BROWNS FERRY NUCLEAR PLANT (BFN) - UNITS 1, 2, AND 3 -
TECHNICAL SPECIFICATIONS (TS) CHANGES TS-431 AND TS-418 -
EXTENDED POWER UPRATE (EPU) - RESPONSE TO ROUND 9 - REQUEST
FOR ADDITIONAL INFORMATION (RAI) - SBWB RAIs (TAC NOS.
MC3812, MC3743, AND MC3744)

TENNESSEE VALLEY AUTHORITY
BROWNS FERRY NUCLEAR PLANT (BFN)
UNITS 2 AND 3

RESPONSE TO ROUND 9 REQUEST FOR ADDITIONAL INFORMATION SBWB-65
THROUGH SBWB-74

RESPONSE TO ROUND 9 REQUEST FOR ADDITIONAL INFORMATION -
SBWB-49 (NON-PROPRIETARY INFORMATION VERSION)

Figure SBWB-65-1
Limiting Axial Power Shape (LOCA)

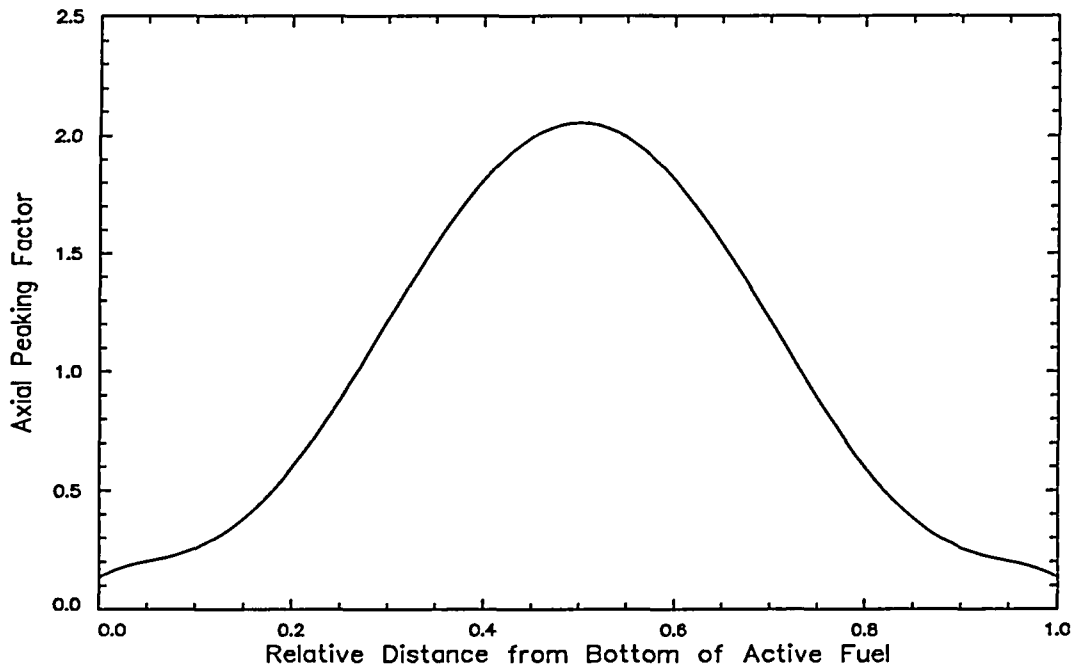
Provide the head flow curves used in the limiting large break loss-of-coolant accident LBLOCA analyses (battery failure case). The curves should include the head flow curve for one low pressure core spray and one low pressure coolant injection pump discharging into each recirculation line. Also, provide the limiting axial power shape used in this limiting break.

The limiting axial power shape in the limiting LOCA analysis is shown below in Figure SBWB-65-1.

Figure SBWB-49-2. Pump Curve for One Core Spray Loop

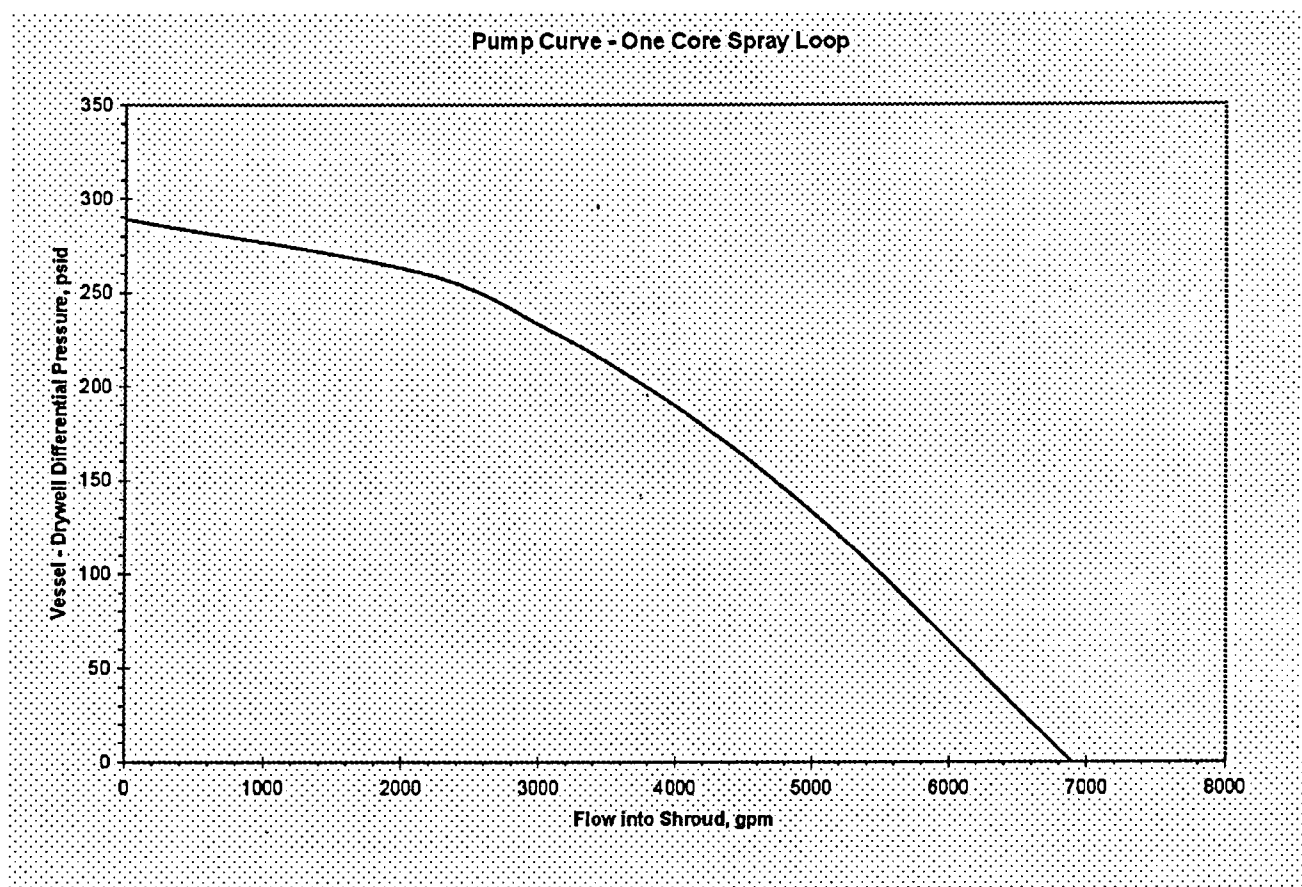
Provide the head flow curves used in the limiting large break loss-of-coolant accident analyses (battery failure case). The curves should include the head flow curve for one low pressure core spray and one low pressure coolant injection pump discharging into each recirculation line. Also, provide the limiting axial power shape used in this limiting break.

Figure SBWB-49-2 shows the flow into the shroud of one core spray loop (two core spray pumps) as a function of the differential pressure between the vessel and drywell.

Figure 3.7.1-1
Reactor Thermal Power Versus Ultimate Heat
Sink Temperature Limit

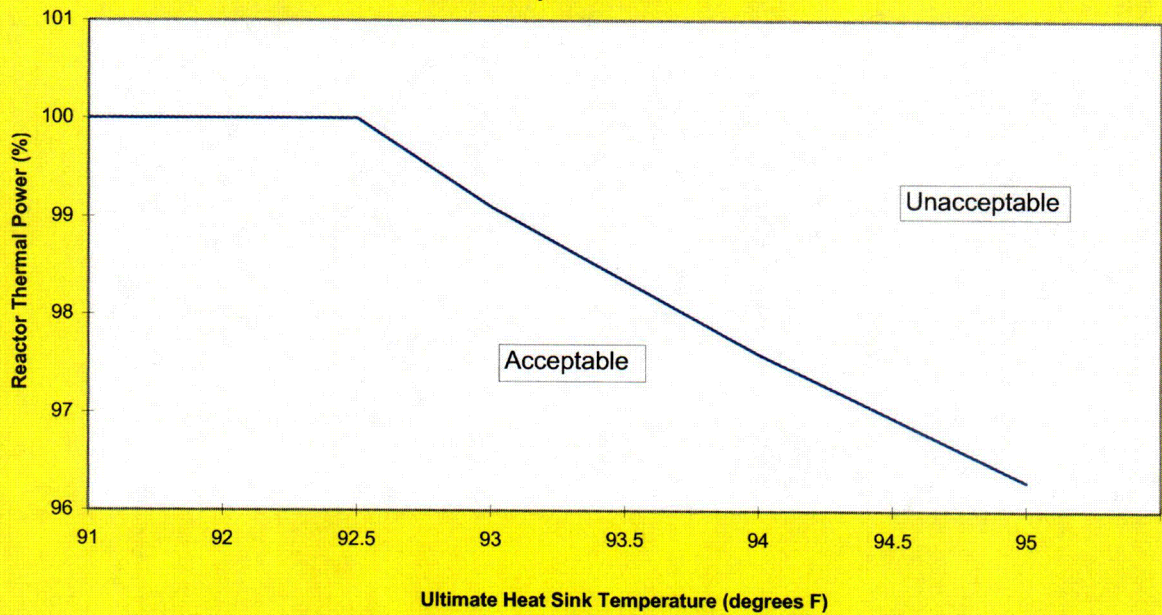
Delete
Figure.

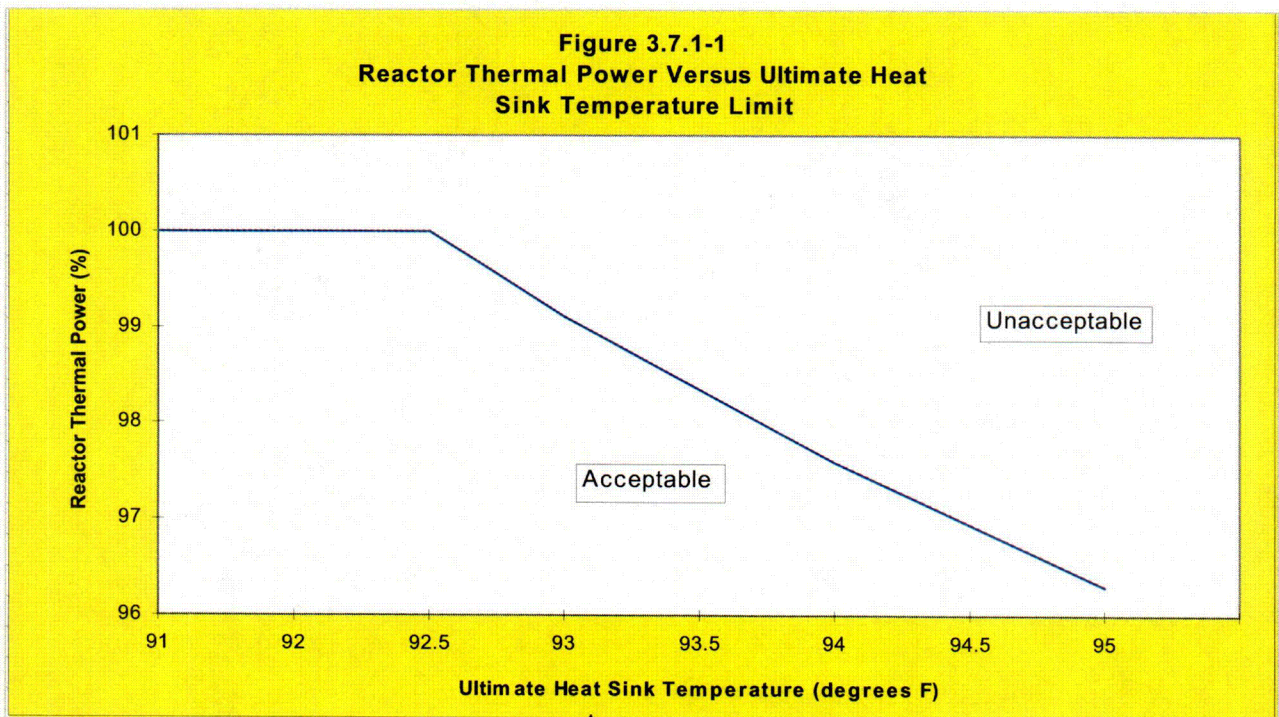
Delete Figure
